This document responds to the comments presented by Mo Madini and Staff from Florida Department of Business and Professional Regulation on the online document: www.floridabuilding.org/fbc/commission/FBC_1018/Energy_Tac/Staff-Comments.pdf. The IESVE team thanks Mo and Staff for the comments (in *black text*), and encourage the interested parties to view the following responses (in green text).

Staff Comment #1: Compliance certificate box should be revised for consistency with Section C103.1.1 of the 6th Edition (2017) Florida Building Code, Energy Conservation

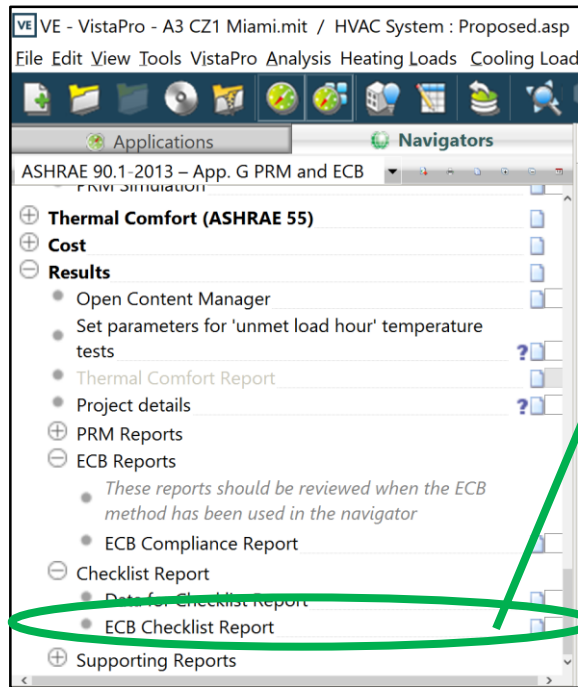
Staff Comment #2: Compliance report should be revised to provide for specific documentation of the proposed building design energy measures for the applicable building systems (building Envelope, Lighting, HVAC, Service Water Heating...etc.)

Staff Comment #3: Compliance report should document compliance with the mandatory requirements of Section 11; Energy cost Budget Method of ASHRAE 90.1 – 13.

Response to Comment #2 and #3: The auto-generated ECB Checklist Report has three sections that show the inputs of the proposed versus ECB Budget (Baseline). The first section shown in Figure 2 is the Envelope; the section in Figure 3 is the Model Input; the last section in Figure 4 is HVAC.

Figure 5: Example report from ASHRAE Website and Auto-generated ECB report from IESVE 2018

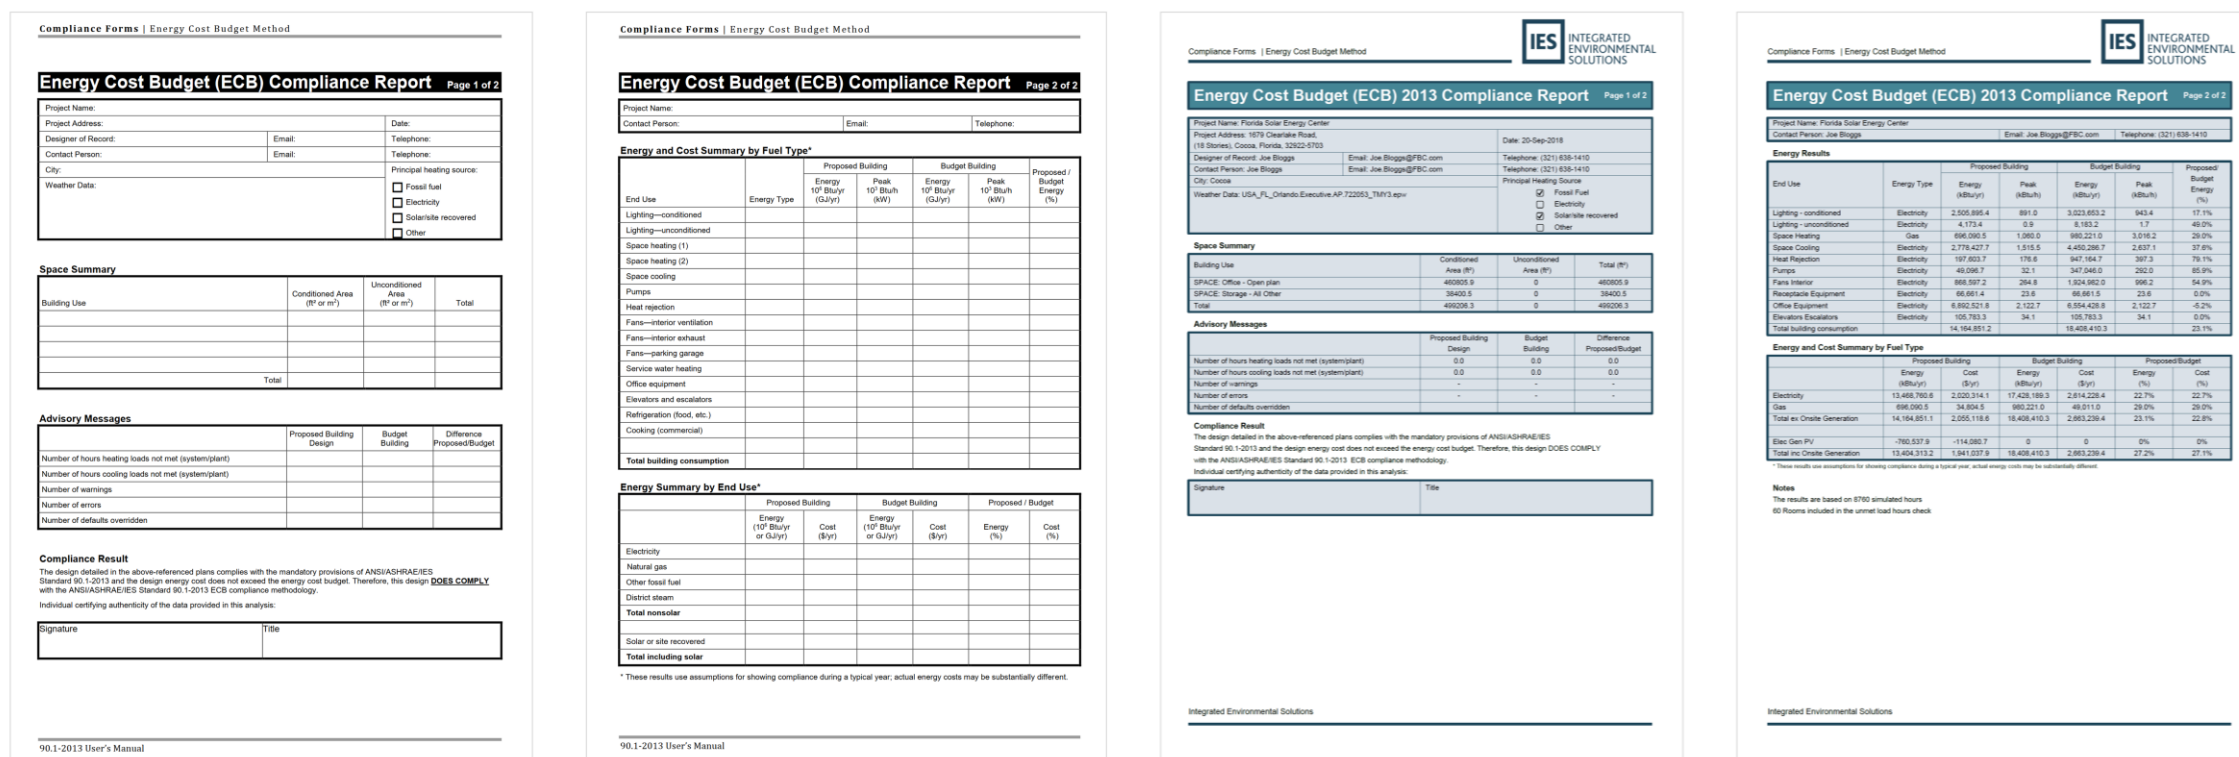
Staff Comment #3: Compliance report should document compliance with the mandatory requirements of Section 11; Energy cost Budget Method of ASHRAE 90.1 – 13.

Response #3 Part 2: The auto-generated ECB Report is based on the layout and requirements prescribed by ASHRAE and the example compliance form on the ASHRAE website, <https://xp20.ashrae.org/UM90.1-2013/ECB-Method-Compliance-Form-2013.pdf> as shown in Figure 5.
